**MACKENZIE PARK**  
**ACCESSIBILITY SURVEY**

**February, 2006**

**CITY OF SANTA**  
**BARBARA**

*Building - Photo # 1*

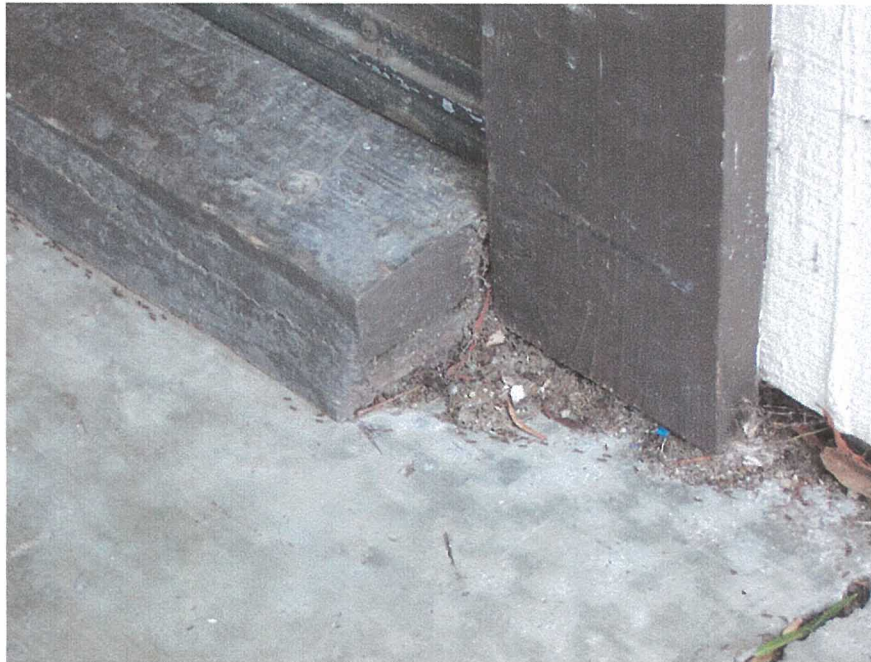
*Door hardware requires tight grasping to operate. Loose doormat needs to be secured. There is not a tactile and Braille room identification signs.*

*Building - Photo # 1*

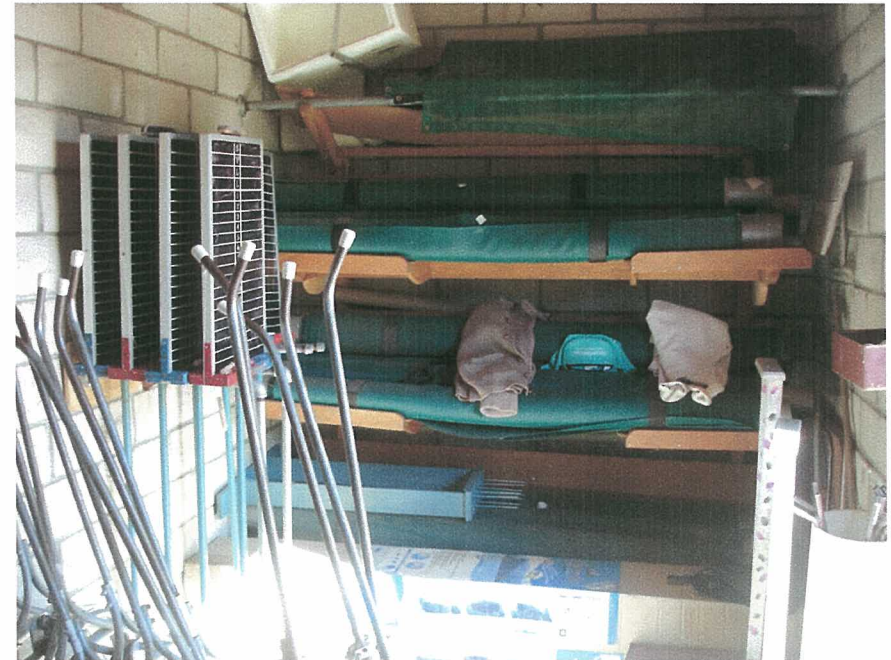
*Door hardware requires tight grasping and twisting of the wrist to operate. There is not a tactile and Braille room identification sign. Step makes this storage room inaccessible. There is no contrasting color striping at step.*

*Building - Photo # 2*

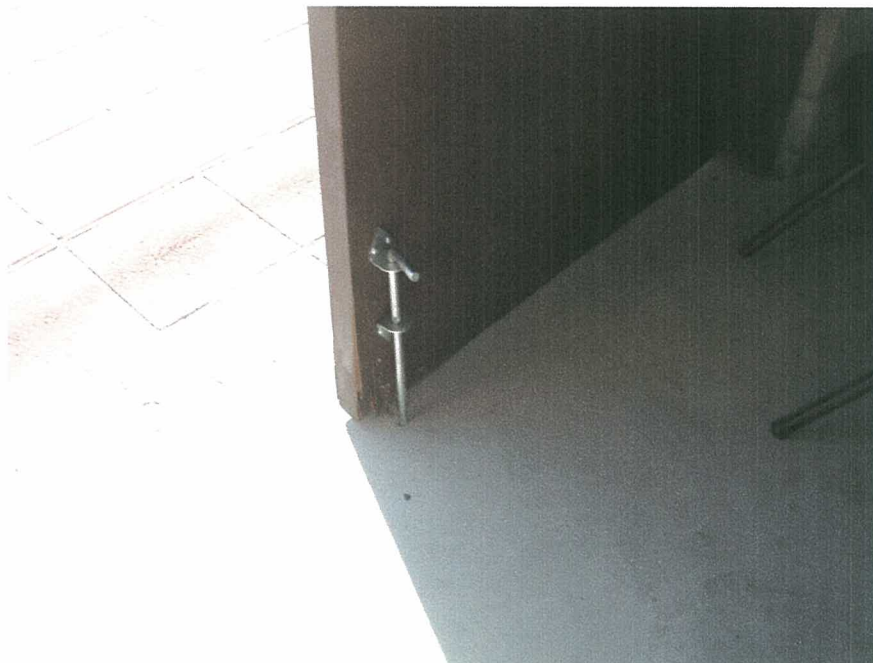
*Equipment storage is not accessible, there is a step to it. Team players assist persons with disabilities retrieving the equipment.*
